**Before the
FEDERAL COMMUNICATIONS COMMISSION
Washington, DC 20554**

In the Matter of)	
)	
Shortwave Modernization Coalition)	RM-11953
Petition for Rulemaking to Amend the)	
Commission’s Rules to Allow Fixed,)	
Long-Distance, Non-Voice)	
Communications Above 2 MHz and)	
Below 25 MHz)

**Opposition of ARRL, The National Association For
Amateur Radio**

Analysis of Shortwave Modernization Coalition Petition to Permit High-Speed Digital Transmissions on Part 90 HF Spectrum

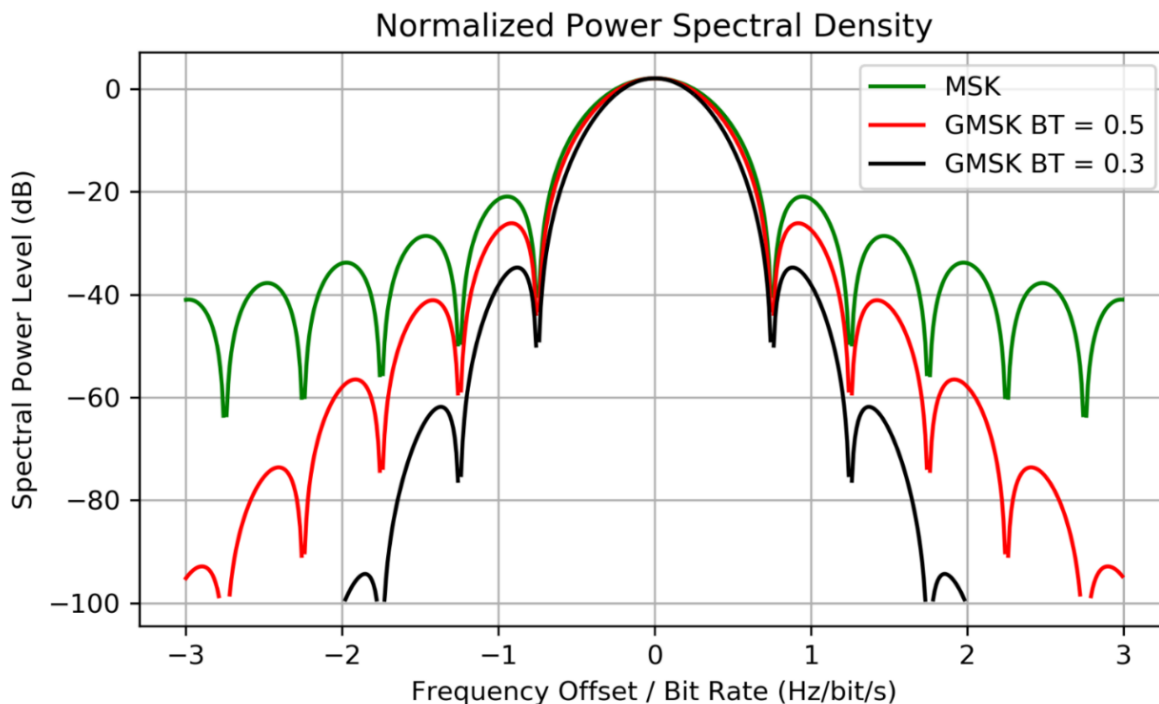
The Coexistence Report estimated that the Part 90 digital station would be using 10 kHz of bandwidth. It therefore reduced the 20-kW transmitter power by 40 dB, to account for the way VOACAP analyzes I/N using a 1 Hz bandwidth. Although this is correct for VOACAP estimates of I/N ratios, it must be noted that

digital modulation is *not* uniformly distributed at the data rates that would reasonably fit into a 10 kHz bandwidth. The following figure shows the actual distribution of several types of digital modulation:

The lobes shown in this figure are *not* intermodulation or distortion, but the actual digital-modulation sidebands, and a part of the information being transmitted. Note that these sidebands are not uniformly distributed but are higher on some frequencies than others. A flat “40 dB” adjustment does not account for the peaks and valleys and does not account for the fact that within the 3 kHz of bandwidth that would be typical of an amateur station, multiple instances of these lobes would be present, with a peak-envelope power that is higher than the average power present in spectrum adjacent to the Part 90 digital transmitter. At a minimum, considering only the shape of the spectral distribution, the power at the peak of one of the lobes would be at least 3 dB greater than the -40 dB correction applied and the peak power in the bandwidth of the receiver being affected could be as much as 10 dB higher. The -40 dB factor used in the Coexistence Report contains yet another error in the wrong direction to support the conclusions of the report.

The proposed rules do not specify minimum or maximum data rates or modulation modes, so the error or assumption could range from 0 dB to 6 or more dB, depending on the modulation mode and data rate chosen by the system designer.
